Parcel 34 Pebb Capital Concept Plan Review

I-195 Redevelopment District Commission Meeting
December 20, 2023

Ground Floor Plan

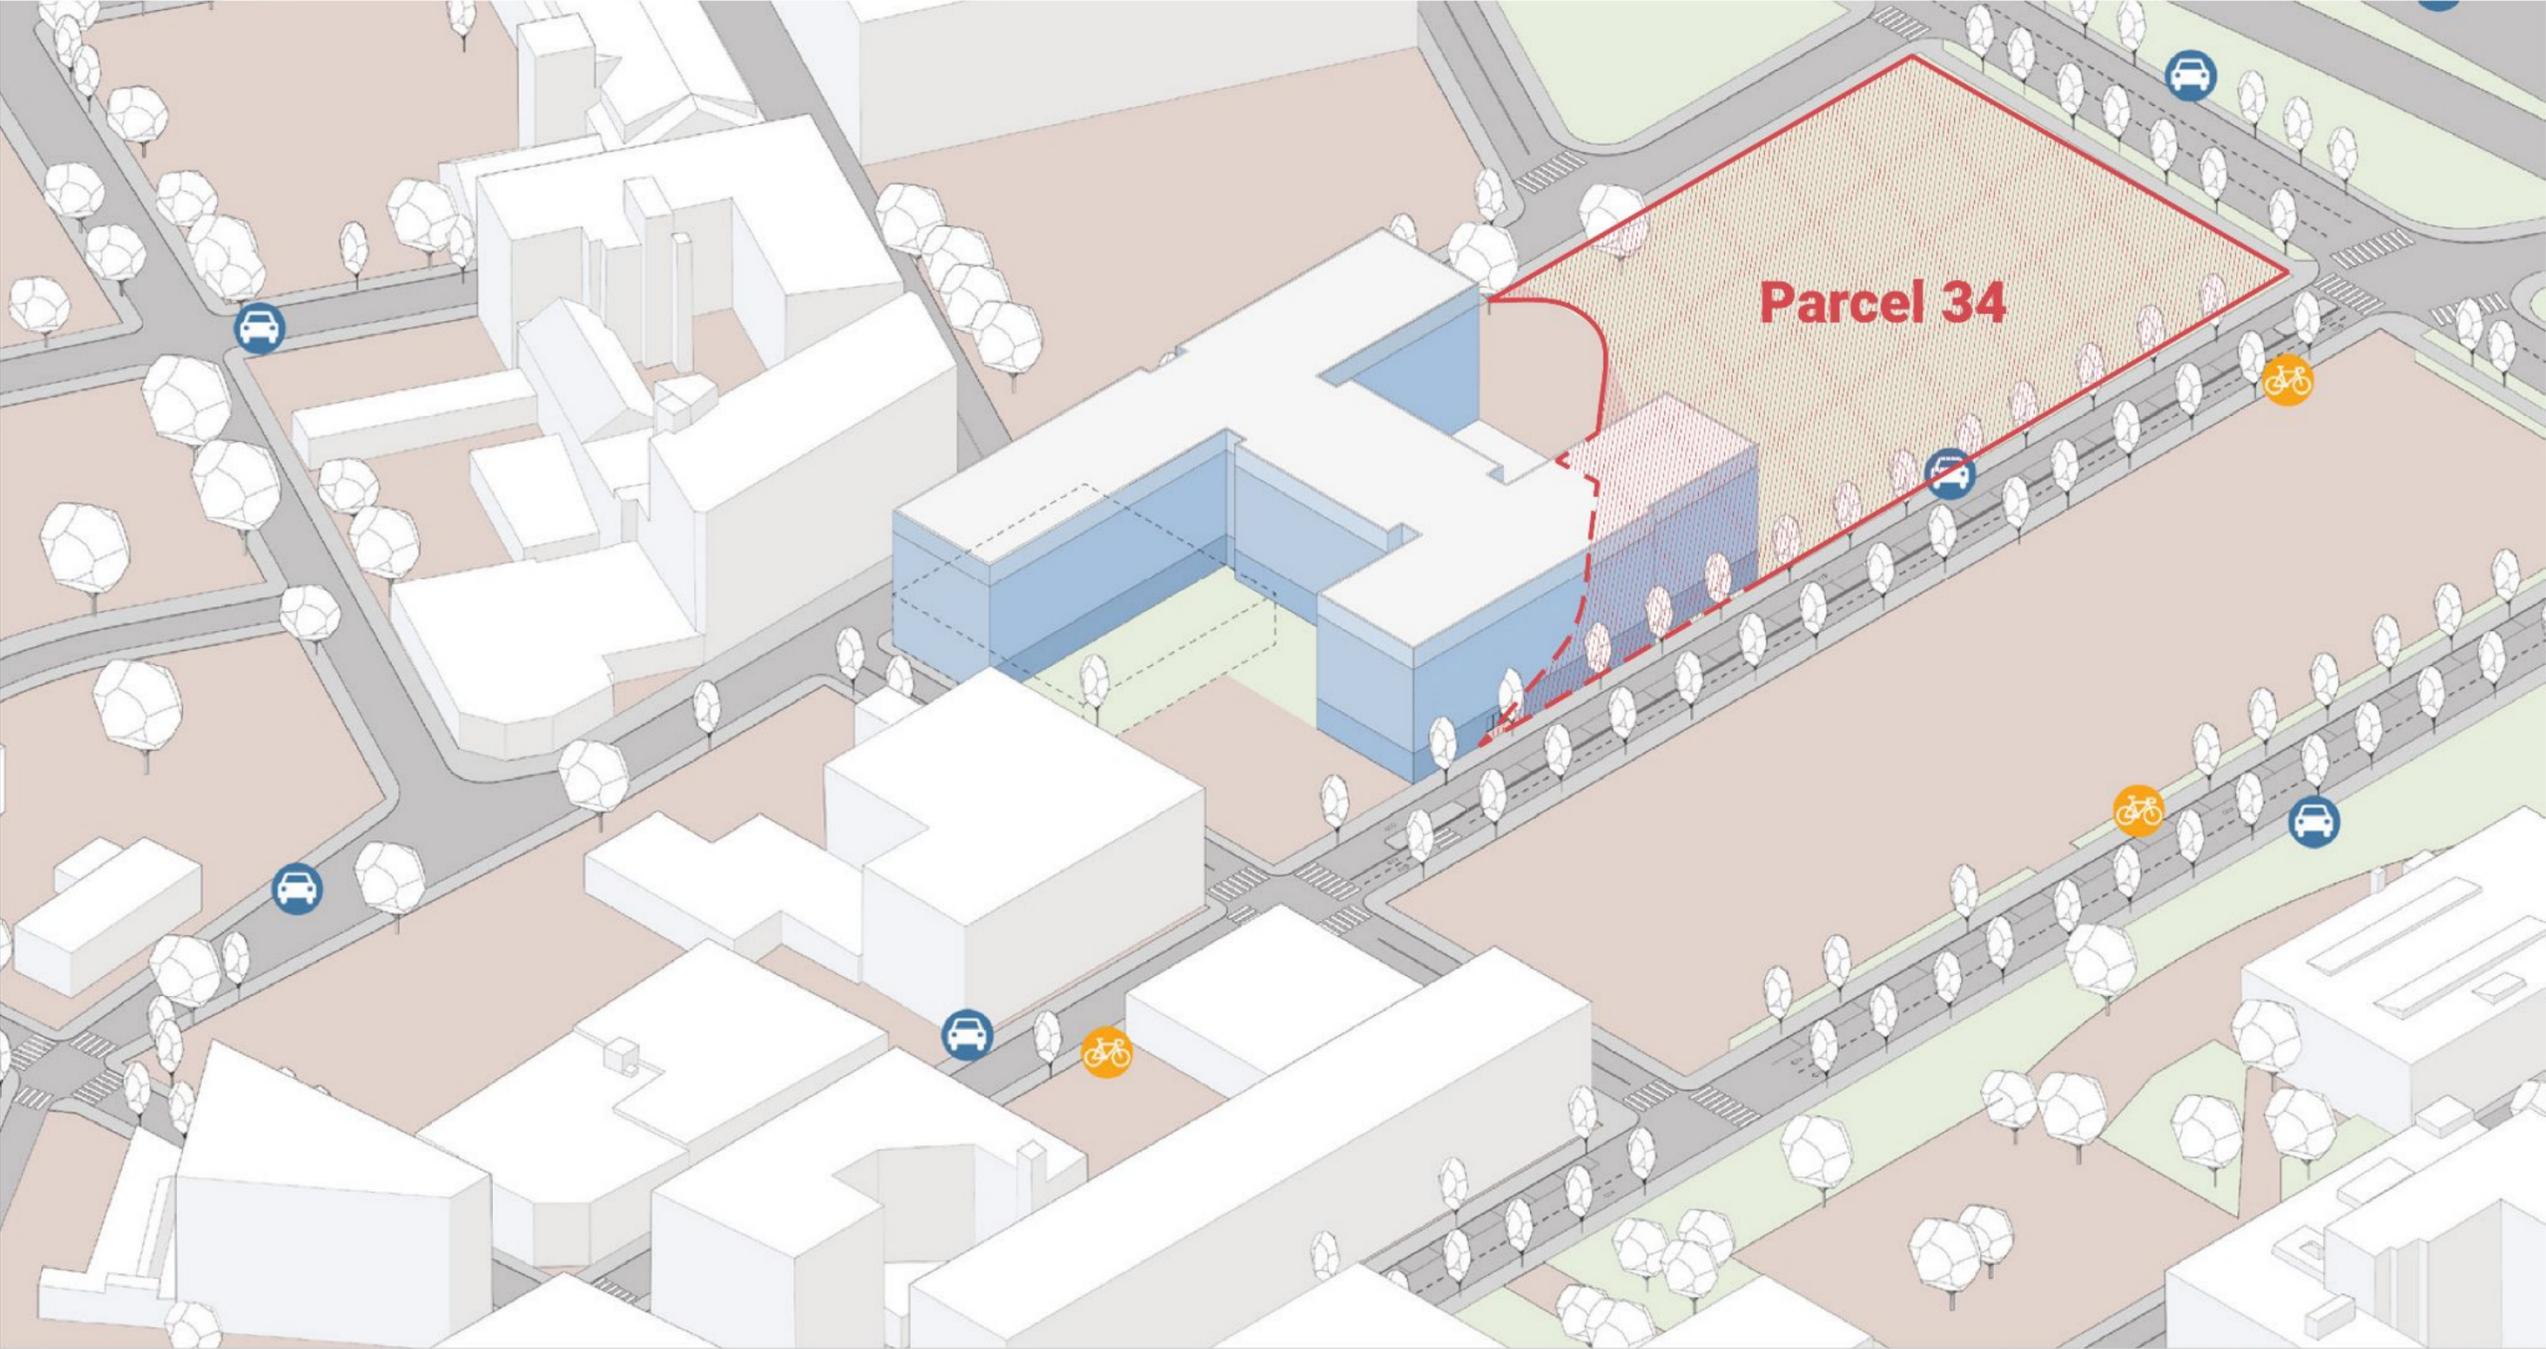
3. **Retaining Wall Treatment:** Clarify the treatment of the retaining wall next to the below-grade parking garage entrance. Specifically, clarify if any railing, fencing, or additional screening treatment will be used above that wall and provide examples of the envisioned treatment.
